Submission of Further Information (FI)

**Proposed Government Use (Maintenance Depot) in “Residential (Group D)” Zone,
Government Land in D.D. 103, Au Tau, Yuen Long
(Application No. A/YL-KTN/1211)**

Further Information for Planning Application No. A/YL-KTN/1211**Response-to-Comments****Comments from Environmental Protection Department**

1:750	Layout Plan	Goldrich Planners & Surveyors Ltd.
June 2026	Government Land in D.D. 103 Yuen long, N.T	Plan 3b (P 25066)

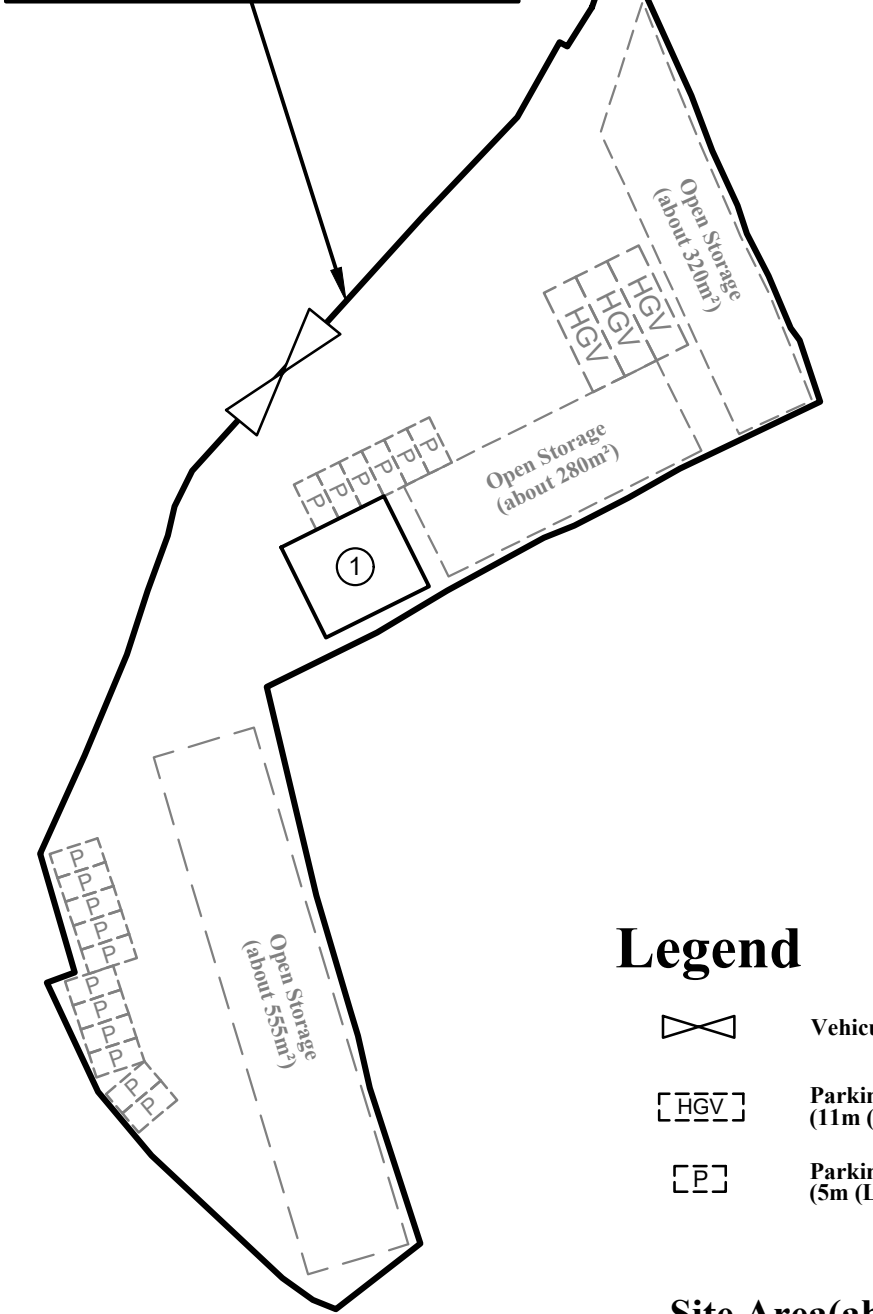
<p>3.</p>	<p>Please justify why the existing local track cannot be used as the vehicular access and a new access is proposed instead. Besides, please elaborate in what situation the emergency exit will be used given there will be a new vehicular access.</p>	<p>We would like to clarify that there is limited turning space for HGV when using the existing local track. As such, a new vehicular access is proposed. The area of the existing local track will be used for open storage space. Please</p>

The location of the vehicular ingress/egress and the layout of the car parking space have been slightly revised.

refer to the revised Layout Plan (Plan 3b) for details.
4.	Please provide information on why the existing maintenance depot in Yuen Long has to be relocated.	The existing maintenance depot in Yuen Long will be returned to LandsD for other potential uses.
5.	Please advise whether peripheral fencing will be provided along the site boundary. If affirmative, please advise the height of the proposed fencing.	Peripheral fencing of about 2.5m high will be provided along the site boundary.

Visual Tree Survey was conducted for the trees within Au Tau Depot

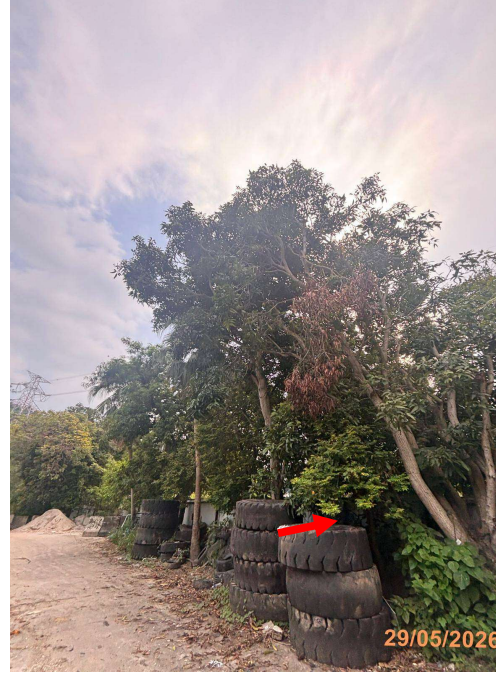
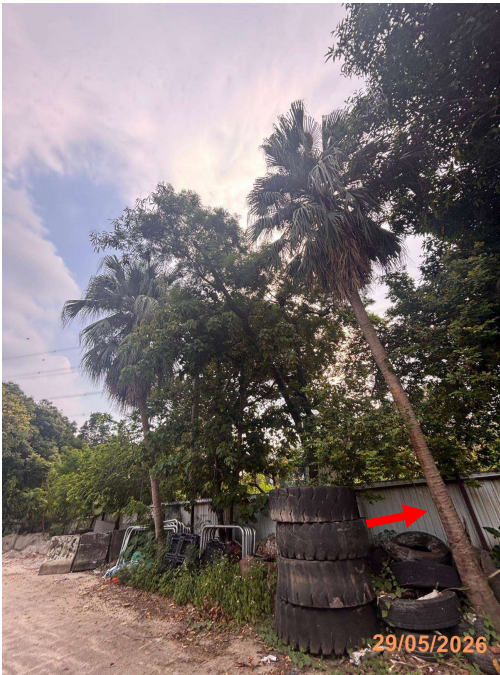
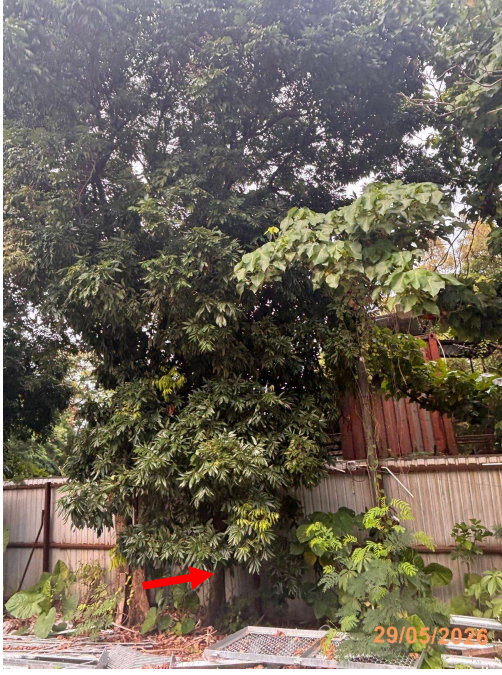
IV.	Comments	Responses
<p>1.</p>	<p>Please advise the move out date of the existing maintenance depot at Yuen Long.</p>	<p>The move out date of the existing maintenance depot at Yuen Long is tentatively scheduled in Q3 2026.</p>
<p>2.</p>	<p>According to the site photos, there are existing trees within the application site, in particular the tree groups at the northeastern part of the site, which is proposed for open storage area and site office. Moreover, site inspection also revealed that the proposed new vehicular access to be constructed on a vegetated slope may be in conflict with the existing trees thereat. In this regard, please provide information on the trees within the Site and those on the vegetated slope for the proposed new vehicular access, including the number, species, location and mitigation measures for proposed tree felling, if any.</p>	<p>There are 61 nos. of trees within the Site and on the vegetated slope for the proposed new vehicular access. All of them are common species and are proposed to be removed as they are in conflict with the proposed development. The proposed tree felling is considered necessary for site formation and for the construction of new vehicular access. The applicant will follow the DEVB Technical Circular (Works) No. 4/2020 on Tree Preservation during the detailed design stage. Relevant tree information is attached for your reference.</p>
